SERVICE BULLETIN

APPLICABILITY: 2013MY XV Crosstrek
2012MY-2013MY Impreza 2.0L Models

SUBJECT: “Reed-Type” Wind Sound from Front Windshield Molding

NUMBER: 12-155-13R
DATE: 10/03/13
REVISED: 10/16/13

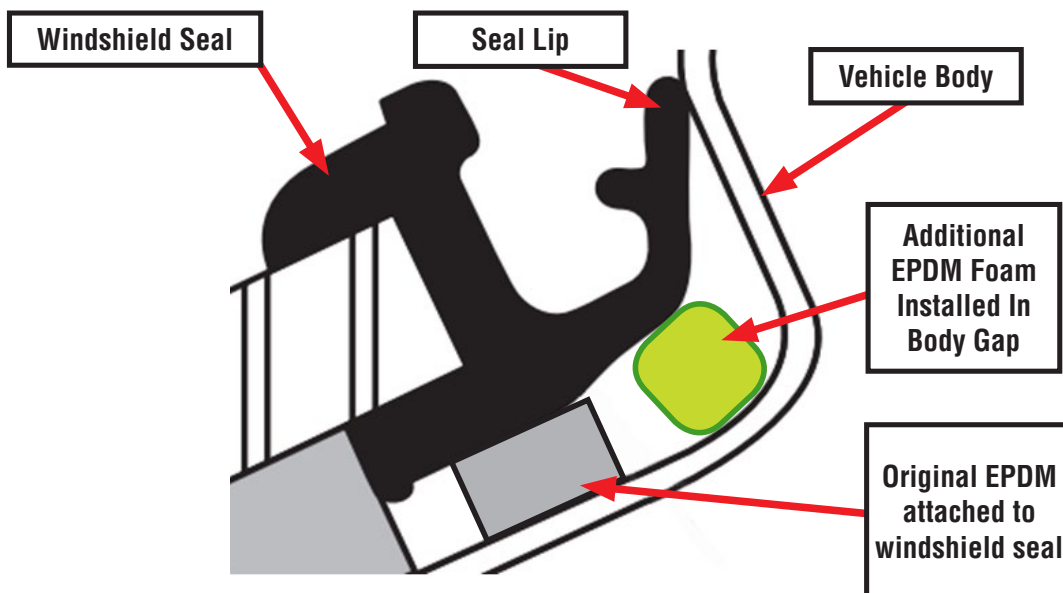
The foam strip has a backing which must be removed to expose its adhesive. The adhesive must be “neutralized” by sticking it to a facial tissue (or equivalent) then peeling it off before beginning the installation otherwise it will stick to the vehicle body or the weatherstrip.

Peeling the backing and sticking the foam to a tissue

Foam after removing it from the tissue and pulling off the excess paper

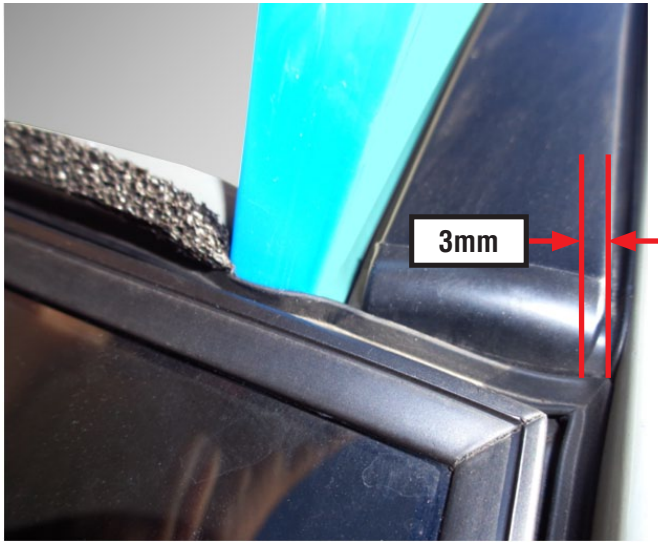
Starting about 3mm from the upper corner of the windshield weatherstrip and using a plastic trim tool, CAREFULLY lift the lip of the seal free of the vehicle body to expose the body gap where the foam strip will be installed. Insert one end of the foam strip then slowly start to work it down into the body gap as you move your trim tool across toward the middle of the vehicle as shown in the photo below, left.

In the photo on the left above, one trim tool was used to lift the seal lip and in the photo on the right, a second trim tool is used to work the foam strip down into the body gap as you move across. Once the foam strip is fully under the seal and into the body gap, use the trim tool to make sure the seal lip is smoothed out and worked back down into its original position. After repeating the procedure on the other side of the vehicle, road test the vehicle to confirm the sound is no longer present. Use a clean shop cloth with a mild solvent (R-M Pre-Kleano #900 or equivalent) on it to wipe the body clean of any remaining residue from installing the foam strip to complete the repair.
